Technical Information Bulletin

Concerning: Main diaphragm retainer 541 control valve

Image 1: New version of retainer

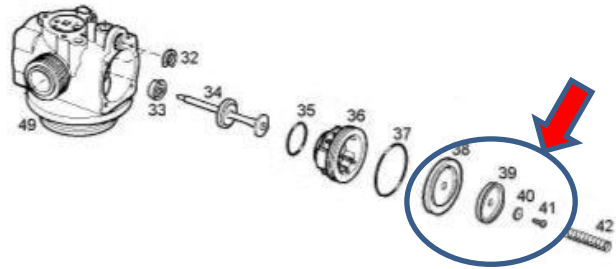
In our continuous efforts to further improve the quality of our products, we implemented a modification on the retainer of the main diaphragm of the 541 control valve for our residential systems.

We have revised the retainer (item 37/item 39) of the main diaphragm, so the washer (item 40) on the current version can be eliminated. The new version is interchangeable with the current version.

This change is introduced in our production, all valves with a serial number higher than 492940 are equipped with this new retainer.
